ITEM #3: For the **ARCHITECTURAL COMMISSION** on **MONDAY, June 16th @ 7:00 P.M.**

REQUEST: Consideration of a request for an amendment to the previously approved Special Use Permit and Planned Unit Development approval known as the Fairfield Village Planned Unit Development and with the R-2 PUD District to provide for a senior living center with Memory Care and Assisted Living Facilities and specifically the signage, landscaping, lighting, site plan/plat and building elevations proposed for the property at 1190 Old McHenry Road, submitted by Harbor Retirement Associates.

RENDERING AT ENTRY
06.03.2014

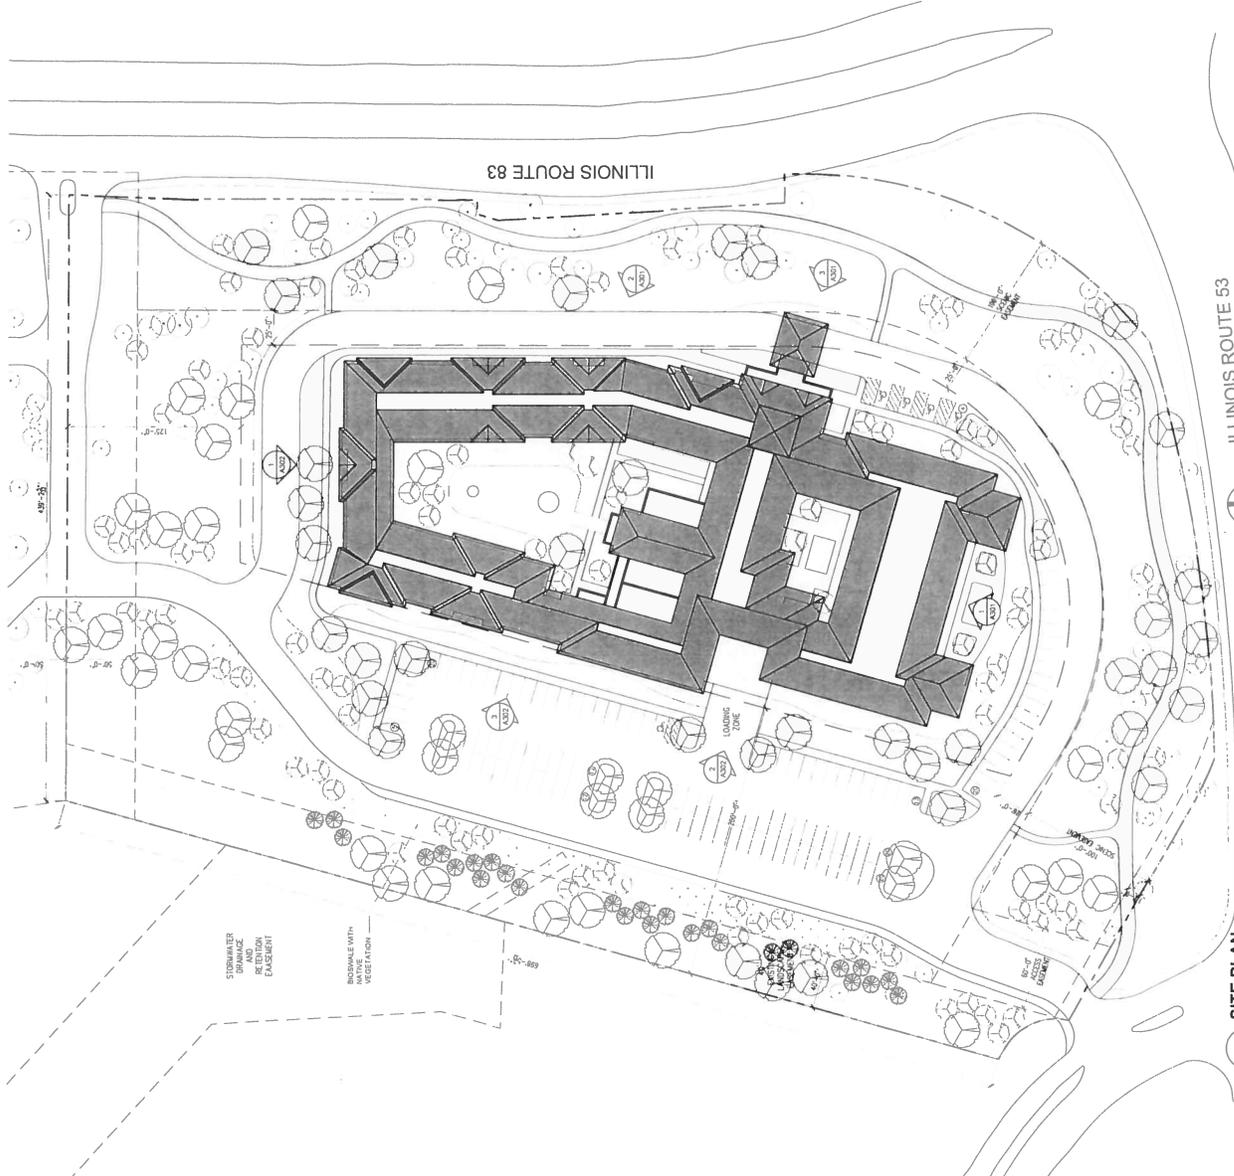
Petitioner has submitted elevations for the proposed structure. As proposed the structure would be two stories tall with building height of 35 feet or less. The only exception to the build height is cupola proposed in the center of the structure. This feature is largely decorative and serves to mirror the architecture in the Sunset Grove Development. Petitioner has asked for relief from the 35’ height maximum to 42’ for the cupola in this proposal.

The structure will be constructed largely of masonry (brick) and hardi-board exterior with stone accents and an asphalt shingle roof (elevations and materials list attached). Elements the building façade were designed to capture the essence of the Sunset Grove development across the street.

Elevations should be considered recognizing the concepts and recommendations of the proposed “downtown master plan” to the greatest extent possible. Coordination of the look of this proposal with other developments in the area (i.e. Sunset Grove) should also be considered.

PLAN SITE
06.03.2014 ZBA SUBMISSION

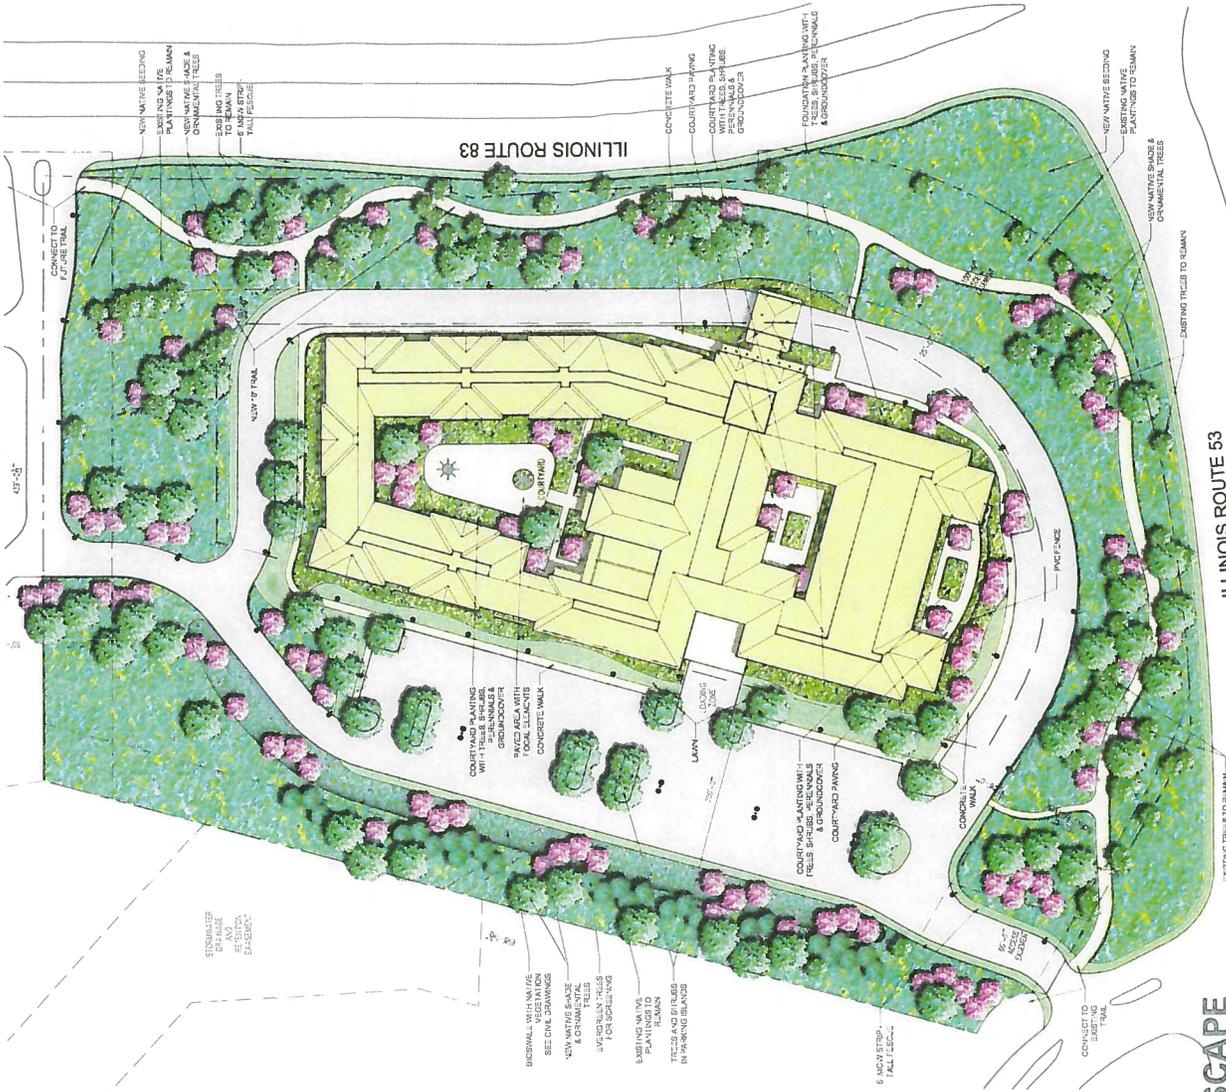
Although no re-subdivision of the property is anticipated a preliminary plan plat is required. This plan identifies particular feature of the development and two items for consideration;

First, alterations to the existing berms, including pathways are contemplated.

Second, demolition of the bank building necessitates that something be done with the cell tower (per the lease agreement). Petitioner proposes that this structure be placed temporarily in the northwest corner of the property until such time as the current lease expires (March 2015). Petitioners would prefer the tower be located off this site.

The site plan/plat as submitted by the petitioner has been carefully crafted to work within the constraints of the approved PUD. These constraints have been an impediment to redevelopment of this property. Of note the site plan is more or less consistent with the current configuration of the site and works within the plat constraints of the PUD as well.

PLAN LANDSCAPE
06.03.2014 ZBA SUBMISSION

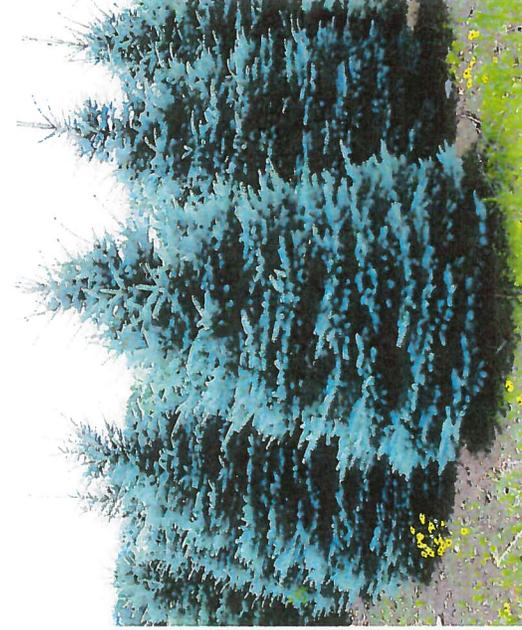
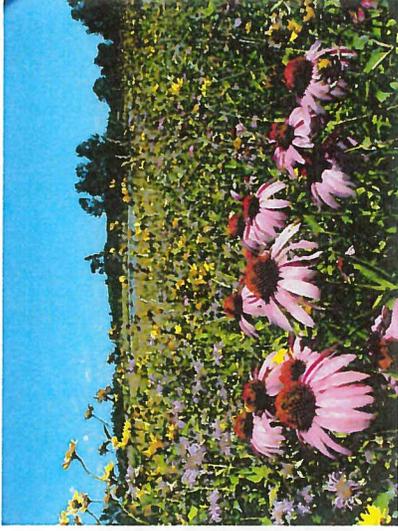
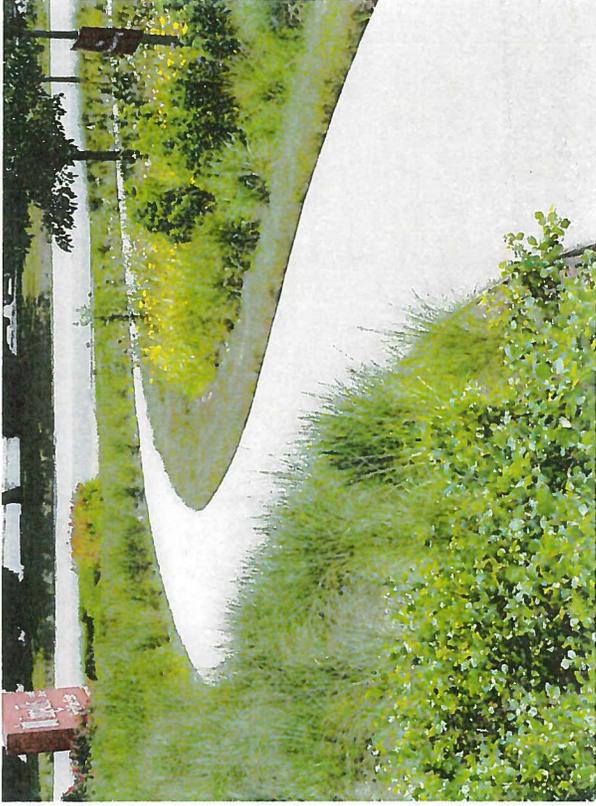
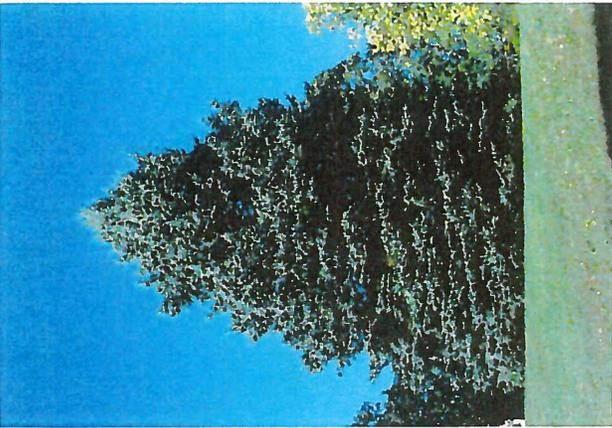
Petitioner has submitted landscape plan for consideration by the AC. As is practical existing trees on-site will be preserved.

The existing 40' buffer yard along the west side of the property will remain as platted and be enhanced with additional planting. As proposed plantings will be largely native shade and ornamental trees. Evergreen trees will also be used and in particular along the western landscape easement.

Review of the landscape plan should be undertaken with consideration of the residential uses to the west. Petitioner has kept parking near the building and increased landscaping along the 40’ buffer yard to the west. Of note the buffer yard area has deteriorated over time and landscaping (as well as maintenance) should serve to greatly improve the effectiveness of this buffer.
